Product Change Notification (PCN)

N° LFPCN230926

Subject: ***PCN for E3 Power Modules Inhouse Assembly Location Transfer***
(Refer to the list of affected parts in page 5)

SUBJECT OF CHANGE:	E3 Bipolar and IGBT Power Modules OSAT Backend Assembly Location Transfer
PRODUCTS AFFECTED:	See page 5
REASON OF CHANGE:	Set the right balance for power modules assembly between internal and outsourced Back End facilities. Extend the E3 packages assembly being built in this facility additionally to other E3 products already built there.

• Inner Box

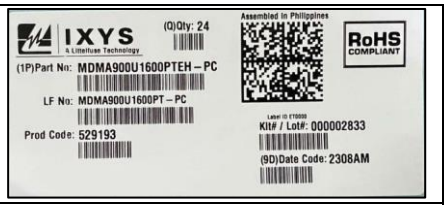
DESCRIPTION OF CHANGE:	**ACTUAL SITE** **Lampertheim, Germany**	**TRANSFERRED SITE** **Laguna, Philippines**
■ Marking (on parts)		
• Type of marking	Laser marking	Laser marking

• Company Logo	Ixys Logo	Littelfuse IXYS Logo
• UL Logo	NO CHANGE	
• Date code + Site Assy code	YYWW**X**	YYWW**AM**
• Catalog Part Number	NO CHANGE	
• 2D Matrix	36 characters 1st to 19th digit: Official product part number 20th to 23rd digit: Date Code (YYWW) 24th to 25th digit: Assembly line 26th to 31st digit: Lot number 32nd digit: Split lot / extra digit for future reference 33rd to 36th digit: Individual module number within one lot	49 characters 1st to 25th digit: Official product part number 26th to 31st digit: Date code (YYWW) 32nt to 33rd digit: Assembly Line 34th to 43rd digit: Lot Number 44th digit: Extra digit for future reference 45th to 49th digit: Individual Module number within one lot
■ Labelling (on packing)
